**Addendum No. 4  
City of Corbin, Kentucky  
Corbin Center Addition Project  
Bid Date: June 3, 2025  
Addendum Issue Date: May 30, 2025**

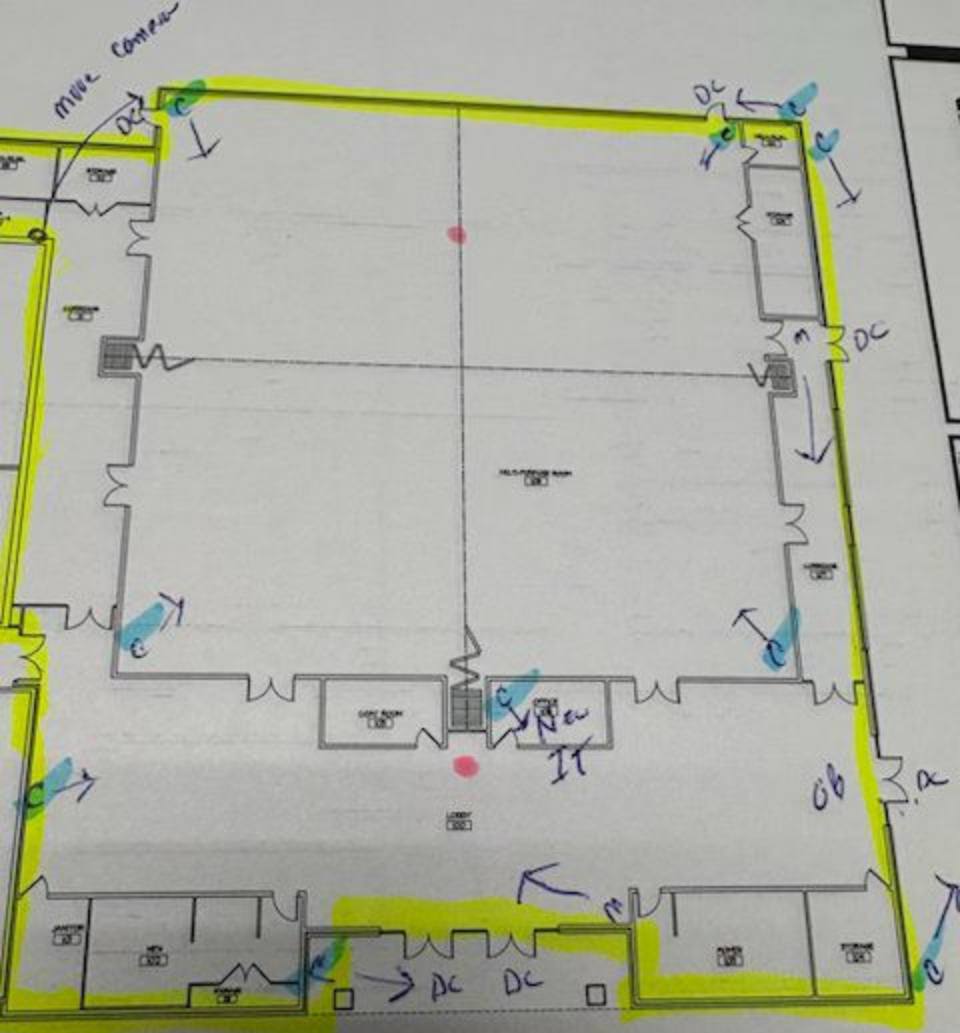
**Item 1:** Attached is a sketch showing the requested additional network drops (12-15 blue highlights) as well as 2 - 120v power connections for wireless security repeaters (pink dots). Cabling for data drops for security cameras shall be the same as specified in Addendum 3 Article 3 - **NAICS 238210 - Telecommunications Wiring Installation, Ceiling Runs for Wireless Access Points.**
